RE: Suntop Solar Farm Modification 1 (SSD-8696-MOD-1) Request for Additional Information

Request 1: Address TransGrid's request for a further relocation of the substation and clarify the impacts of a revised location.

Figure 1: Plan of requested relocation of Substation

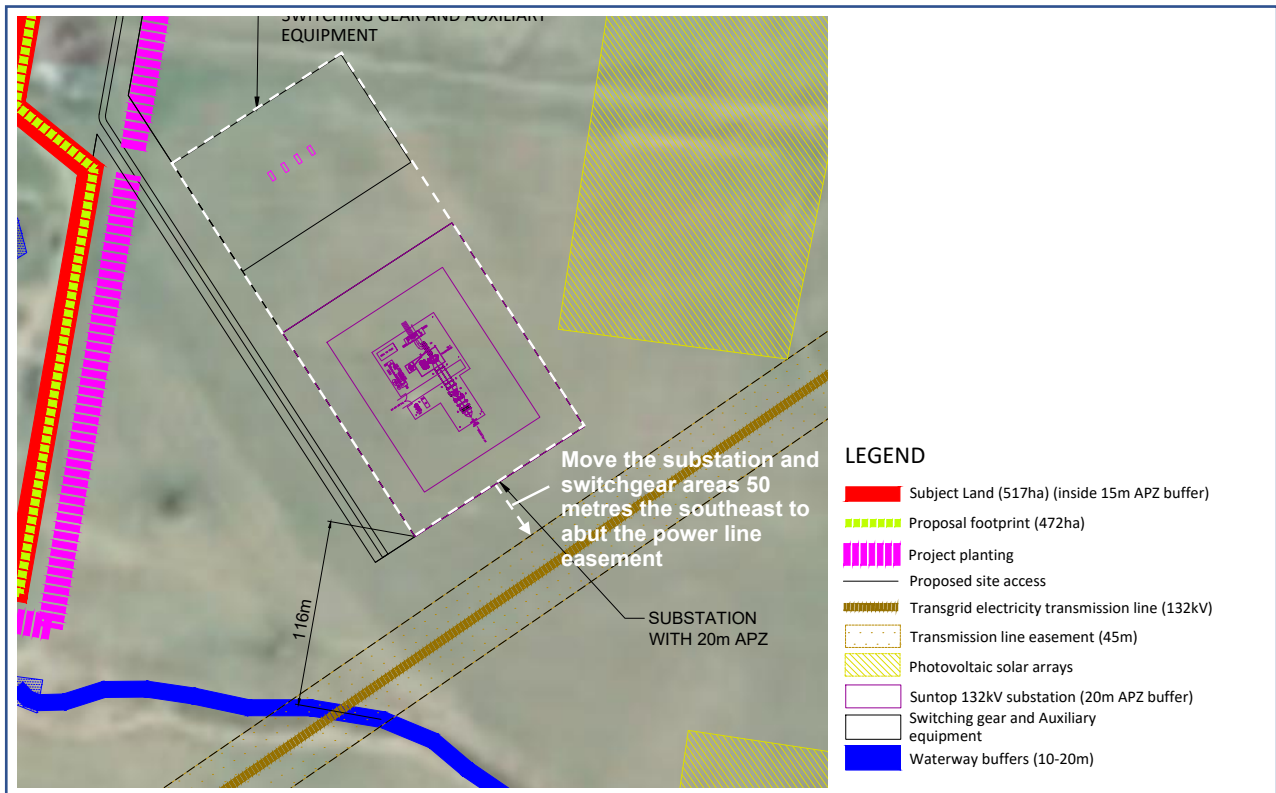
In response to feedback from TransGrid, the substation and switchgear/auxiliary building areas have been moved approximately 50 metres southeast from their position shown in the submitted Modification Plans. The purpose of this further relocation of the substation is to ensure TransGrid do not require the creation of a further powerline easement between the substation and the existing 132kV powerline easement. The change requested by TransGrid is shown in Figure 1 and outcome from this change is shown in Figure 2 below.

Figure 2: Outcome of substation relocation as requested by TransGrid

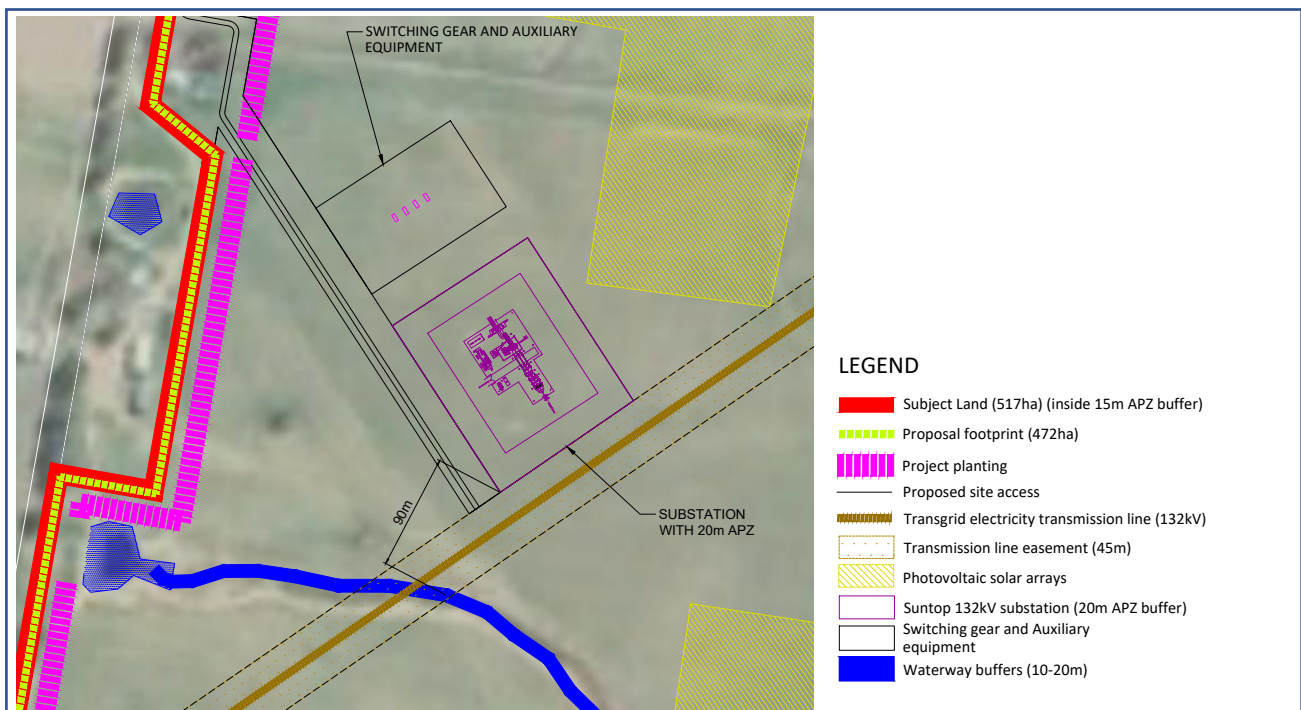
The resultant layout from making the requested change by TransGrid is shown in Figure 2 below for reference. The setback between the powerline easement and the substation area boundary has been removed. The arrangement of the substation and the switching gear/auxiliary building areas remain unchanged.

TG confirms that the revise site plan drawings for Suntop Solar Farm are in line with our understanding of the substation land adjoining the existing transmission line easement.
